Tees CCPP Project

The Tees Combined Cycle Power Plant Project

Land at the Wilton International Site, Teesside

Implications of Requested Change on the EIA

Figure 1 Viewpoints (VP) Corresponding to Clusters A to D and Scheduled Monuments

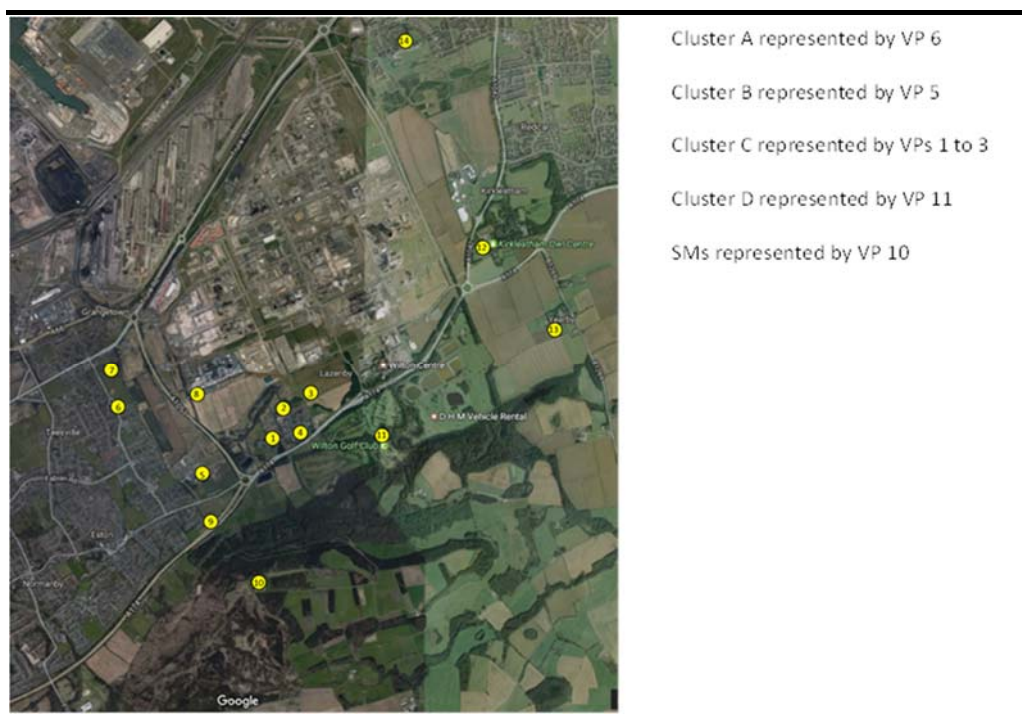
1.22 The designated assets as described in the ES have been grouped into four 'clusters' as shown on Figure 1 below. These clusters are broadly represented by some of the viewpoints ('VP') used in the landscape and visual impact assessment, namely: cluster A represented by VP 6; cluster B represented by VP 5; cluster C represented by VPs 1 to 3; cluster D represented by VP 11; and the two Scheduled Monuments represented by VP 10.

1.23 As can be seen in Table 2.1 earlier in this document, the landscape and visual assessment of the requested change does not alter the magnitude of impact or significance of effects at any viewpoint. This includes for example the viewpoint 10 Eston Nab Scheduled Monument where the requested change will be most visible since the Project will not be screened as in the closer views. However, from this long distance view the Project will be viewed in

the context of the industrial setting with the Project's main stacks and larger buildings still dominating the overall visual effect.

1.24 The conclusions within the cultural heritage assessment of the ES are therefore unaffected by the proposed building height alterations.
